CERTIFICATE OF APPROPRIATENESS**Application Date:** April 12, 2024**Applicant:** Tim Cisneros, agent for, Sonny BazBaz, owner**Property:** 3400 White Oak Dr, Lots 11 & 12, Block 279, Houston Heights Neighborhood Subdivision. The property includes a historic 9,640 square foot, two-story brick veneer commercial situated on a 13,198 square foot (132' x 100') corner lot.**Significance:** Contributing Storefront brick commercial, constructed circa 1930, located in the Houston Heights South Historic District. Approved COA in Dec. 2022 to remove non-historic brick on south elevation and install doors/windows on east elevation at existing and infilled openings. Approved at Nov. 9, 2023 for alteration to right (East) elevation ONLY.**Proposal:** Alteration: Storefront Front Façade, Side and Rear Elevations**No Changes to Existing Roof.****ALL PROPOSED WINDOWS AND DOORS IN METRO STEEL IN A DARK BRONZE COLOR****Front (South) Elevation**

Recommendation: Denial - does not satisfy criteria	1, 3-7, 9 and Houston Heights Design Guidelines
HAHC Action: -

Proposed Front (South) Elevation

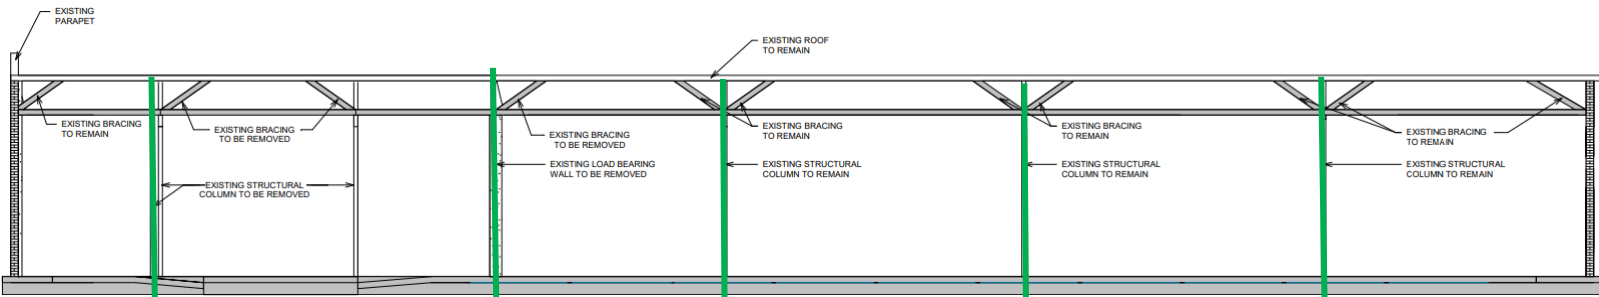
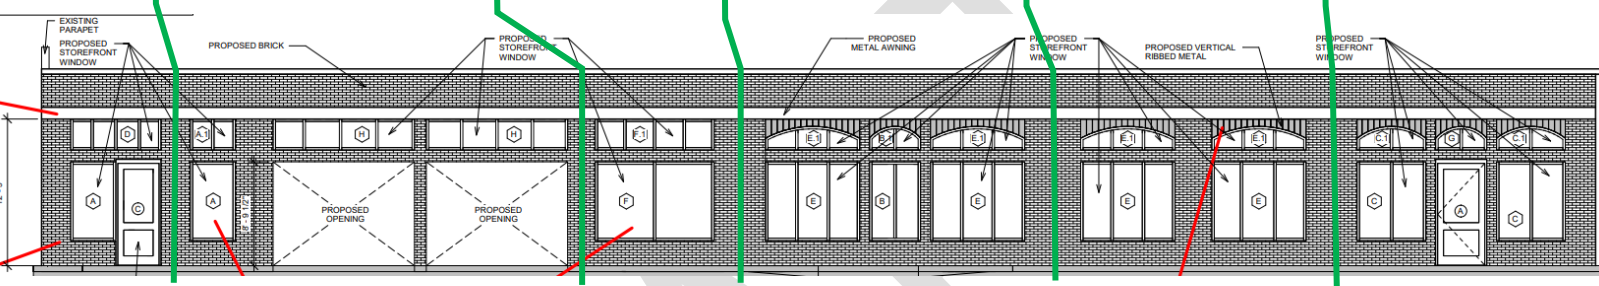
| <input type="checkbox"/> | <input checked="" type="checkbox"/> | <input type="checkbox"/> | (1) The proposed activity must retain and preserve the historical character of the property; The proposed front elevation does not preserve the historical character of the façade. A storefront is the most important architectural feature of historic commercial buildings. |
| <input type="checkbox"/> | <input checked="" type="checkbox"/> | <input type="checkbox"/> | (3) The proposed activity must recognize the building, structure, object or site as a product of its own time and avoid alterations that seek to create an earlier or later appearance; The proposed front elevation creates a later appearance. The existing openings (doors & windows) shows a distinguishing feature pattern of regularly spaced load-bearing brick columns, door openings, window openings, and window sashes, particularly on the right half of the façade where there exists semicircle sashes. The proposed metro steel in bronze color framing for the windows and doors creates a later appearance – creating a contemporary appearance – and DOES NOT recognize the building/structure as a product of its own time. |
| <input type="checkbox"/> | <input checked="" type="checkbox"/> | <input type="checkbox"/> | (4) The proposed activity must preserve the distinguishing qualities or character of the building, structure, object or site and its environment; The proposed front elevation removes the distinguishing fenestration configurations and does not preserve the storefront’s distinguishing architectural feature. Storefront doors were often flanked by large, display windows. The removal of several door openings does not preserve the storefronts distinguishing quality and historical character. Transoms above the display windows became key elements in early 20th century storefronts. These transoms of the past could be opened to permit air circulation into the store. Proposed openings on rear (North) elevation does not preserve the environment nor the quality and character of the building. |
| <input type="checkbox"/> | <input checked="" type="checkbox"/> | <input type="checkbox"/> | (5) The proposed activity must maintain or replicate distinctive stylistic exterior features or examples of skilled craftsmanship that characterize the building, structure, object or site; The proposed front elevation does not maintain nor does it replicate the distinctive fenestration configurations. The proposed front elevation eliminates a brick column and door/window opening for the widening of a vehicle bay. This elimination diminishes its historical character. |
| <input type="checkbox"/> | <input checked="" type="checkbox"/> | <input type="checkbox"/> | (6) New materials to be used for any exterior feature excluding what is visible from public alleys must be visually compatible with, but not necessarily the same as, the materials being replaced in form, design, texture, dimension and scale; Replacement of once existent brick columns with Acme brick in shamrock color ARE NOT visually compatible with the materials that once existed in form, design, and texture. The proposed metro steel in bronze color for the doors and windows ARE NOT visually compatible as the evidence from the once existent front façade showed the original fenestration – doors and windows – were framed in wood. Proposed acme brick of shamrock color where large wood beams placed horizontally that spanned the width of the front façade ARE NOT visually compatible with the materials being replaced. |
| <input type="checkbox"/> | <input checked="" type="checkbox"/> | <input type="checkbox"/> | (7) The proposed replacement of exterior features, if any, should be based on an accurate duplication of features, substantiated by available historical, physical or pictorial evidence, where that evidence is available, rather than on conjectural designs or the availability of different architectural elements from other structures; The existing front elevation shows physical evidence of a distinctive fenestration pattern including semicircle window sashes on the right half of the elevation. The proposed front elevation does not accurately duplicate the existing fenestration openings as it removes several door openings, display windows, and transom windows along with a character-defining semicircle sashes in the transoms on the right half of the front elevation. The proposed replacement of the doors and windows with metro steel in |

a bronze color is NOT based on an accurate duplication of features. The proposed replacement of the horizontal wood beams that spanned the width of the front façade situated between the transom windows and storefront doors/windows is NOT based on an accurate duplication of features.

Existing Structural Supports on Front (South) Elevation

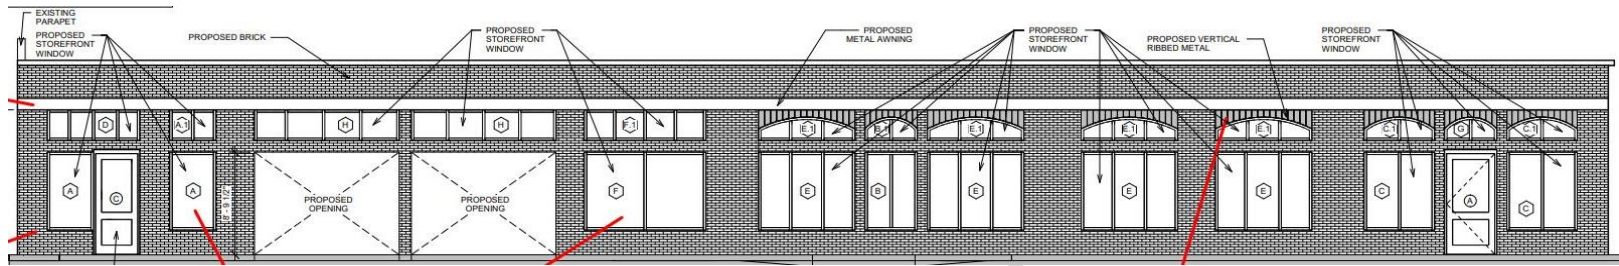
- In accordance with Sec. 33-276, the proposed activity must comply with the City Council approved Design Guidelines. **The removal of the studs, door and window framing, and cross beams that are evident on the front elevation does not preserve the historic building materials.**

Evidence showed wood beams ran horizontally across the width of the facade

Interior Photos of Window and Door Framing Taken By Staff March 1, 2023

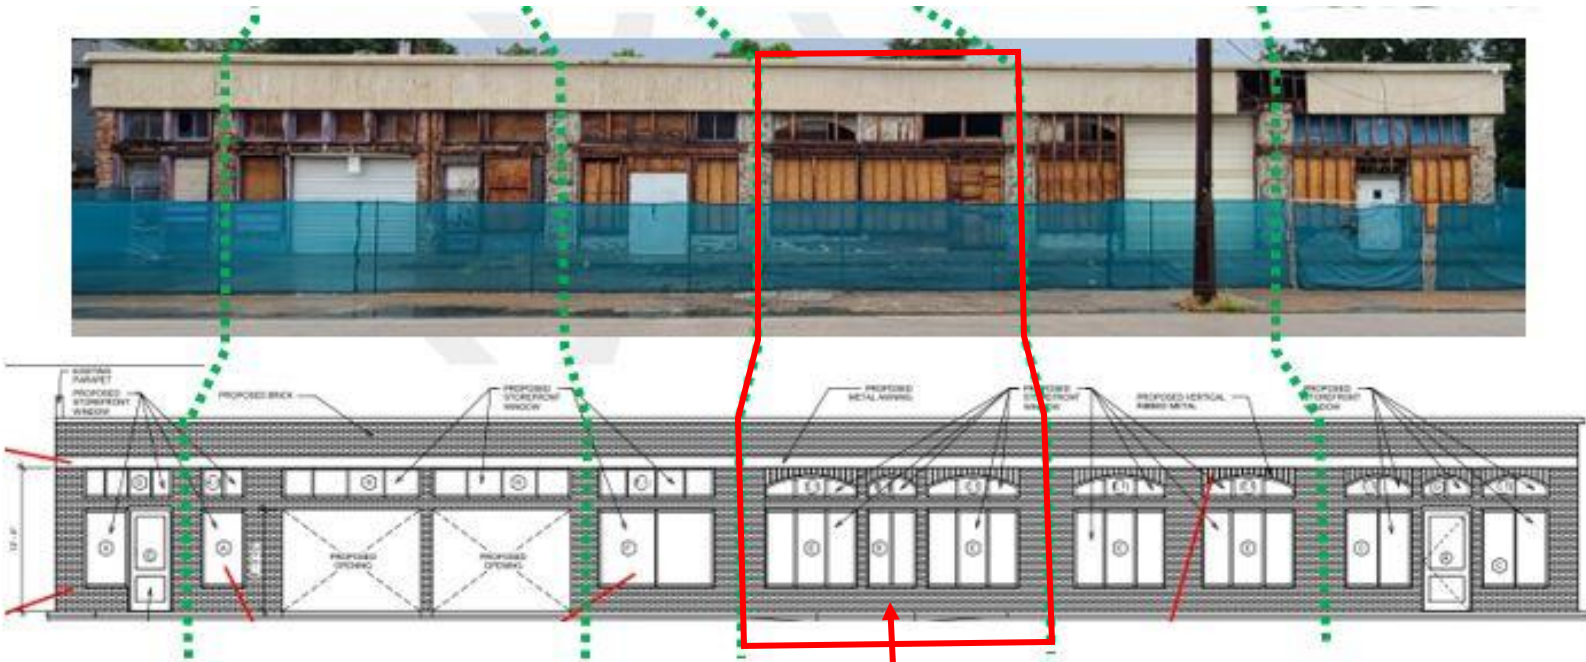
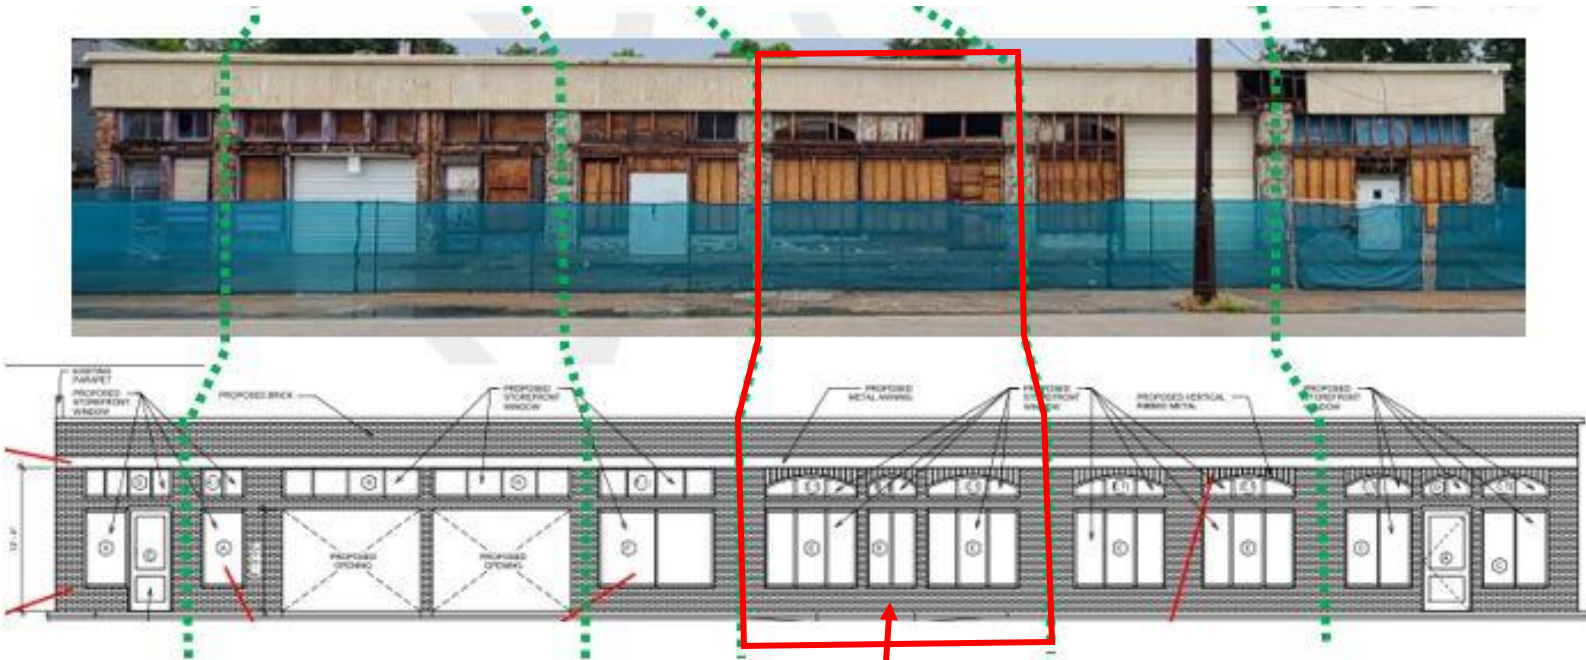
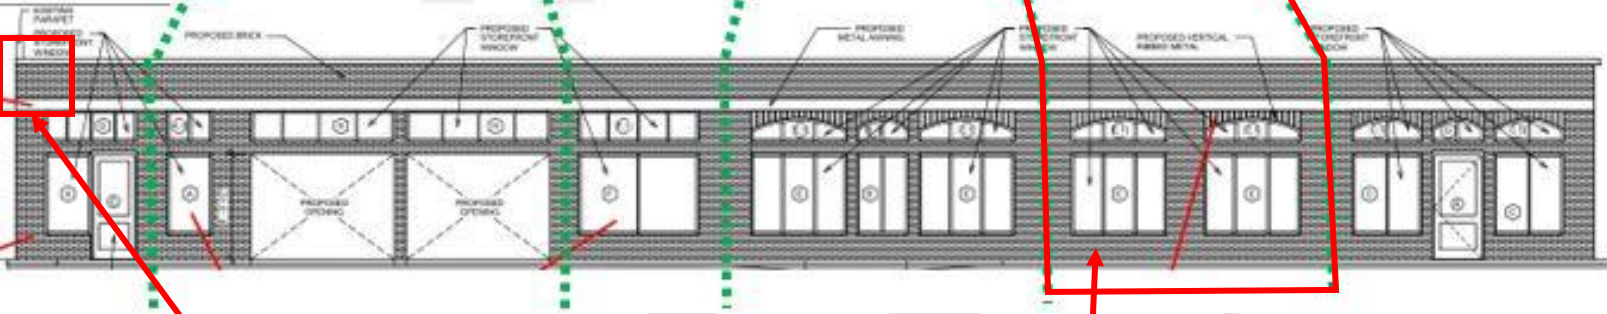
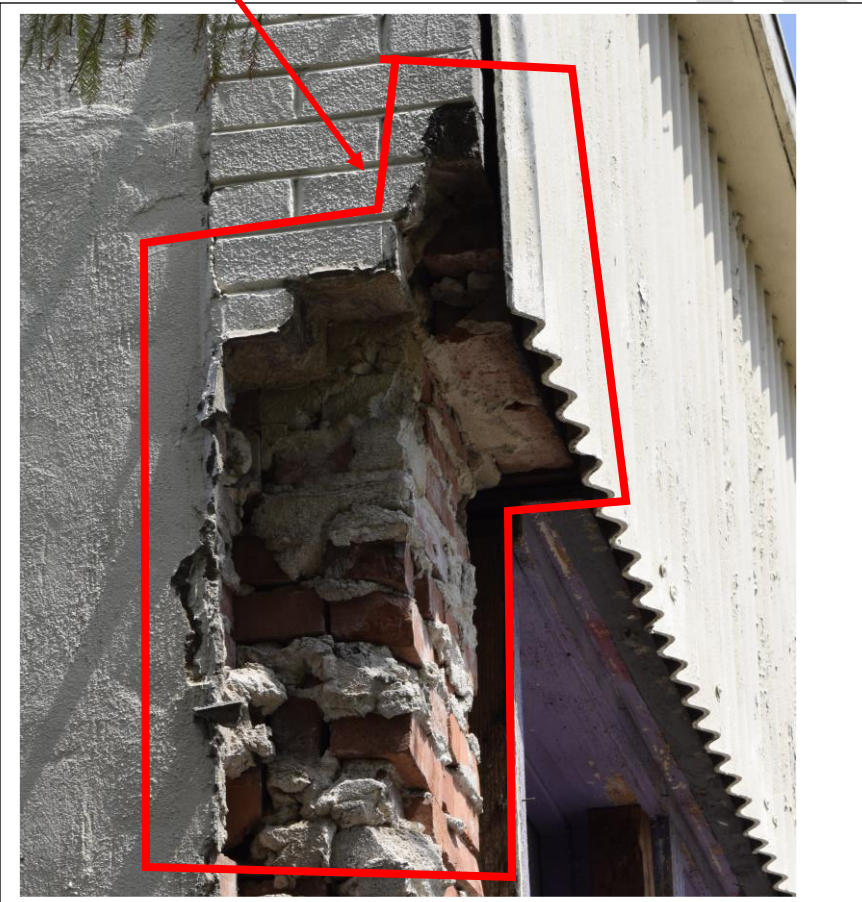
- (9) The proposed design for any exterior alterations or addition must not destroy significant historical, architectural, archaeological or cultural material, including but not limited to siding, windows, doors and porch elements; **The wood studs, door and window framing, semicircular window sashes, and cross beams are in repairable condition. These can be repaired and put back into its original locations. The complete removal of these wood studs and framing would destroy significant architectural materials.**
